RACK HANDLING AND INSTALLATION INSTRUCTIONS

SOUTH TEXAS PROJECT SPENT FUEL STORAGE RACKS  
UNITS 1 & 2  
HOUSTON LIGHTING & POWER COMPANY

ANNOTATED REVISIONS TO THE HIGH  
DENSITY SPENT FUEL RACK SAFETY  
ANALYSIS REPORT AND THE STP FSAR

South Texas Project Electric Generating Station  
Units 1 and 2  
Docket Nos. STN 50-498, STN 50-499  
Response to NRC Questions Regarding the  
Use of High Density Spent Fuel Racks

Figure 3-1

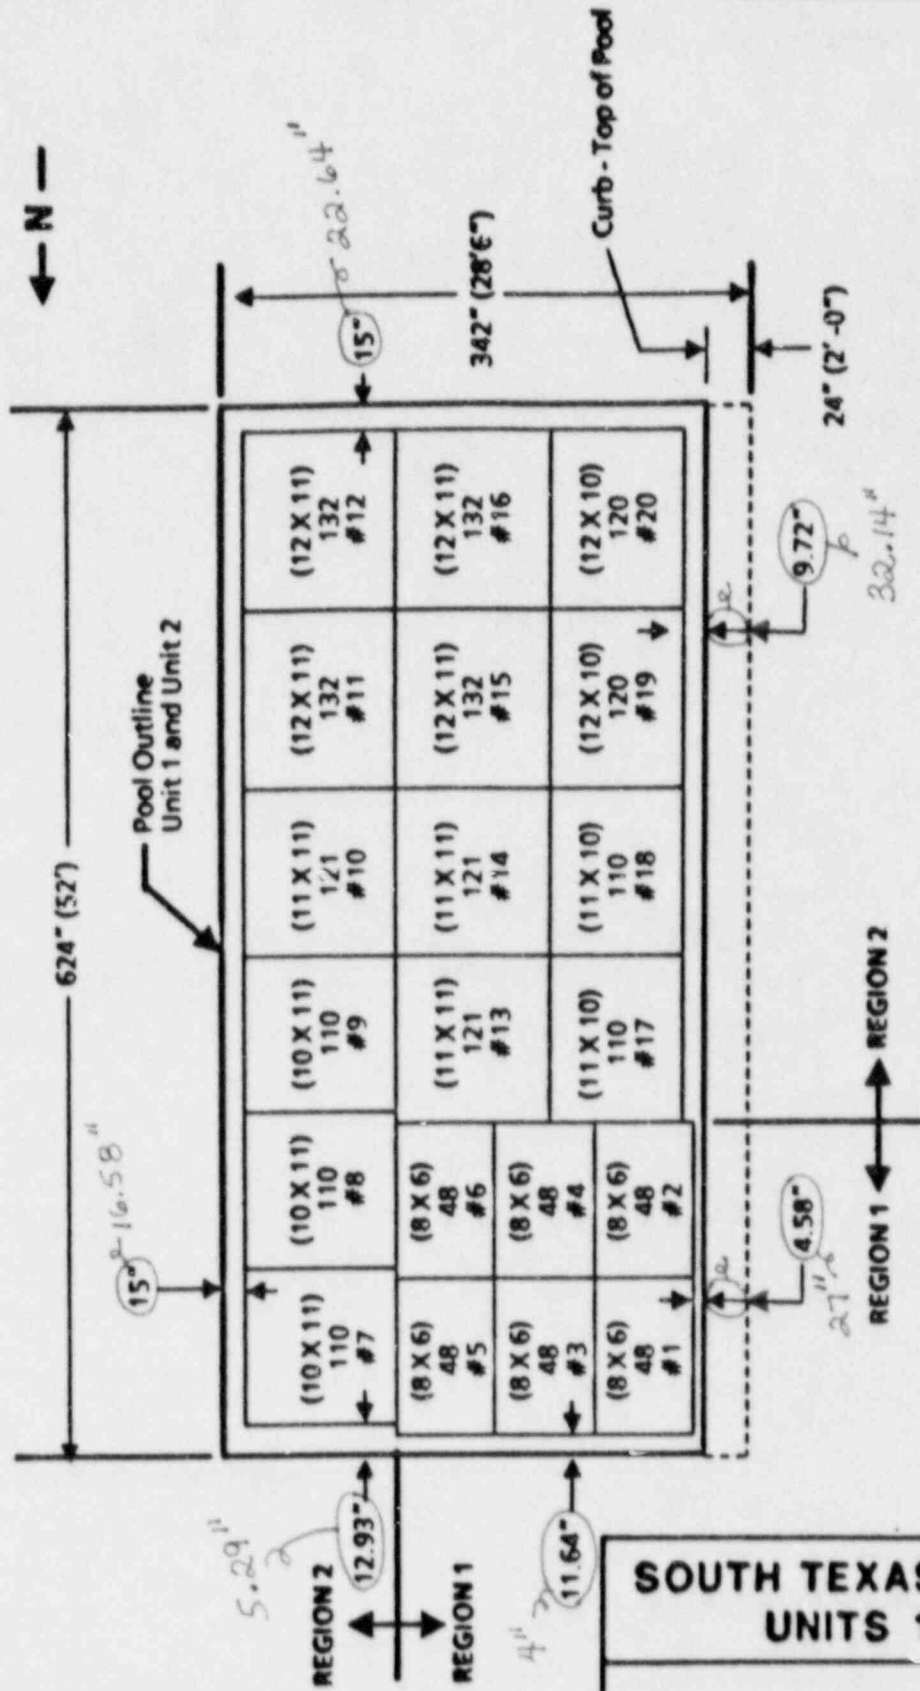
The maximum displacement,  $\delta$ , consisting of the rack displacement associated with five OBE events plus one SSE event was calculated. The total calculated displacement is 5 (0.1803) inches + 1(0.9638) inches = 1.8653 inches. The calculated maximum displacement (1.8653 inches) is less than the 11.64 inches minimum rack-to-wall gap provided at the north end of the pool, the minimum separation between the pool and the rack (Figure 3-1).
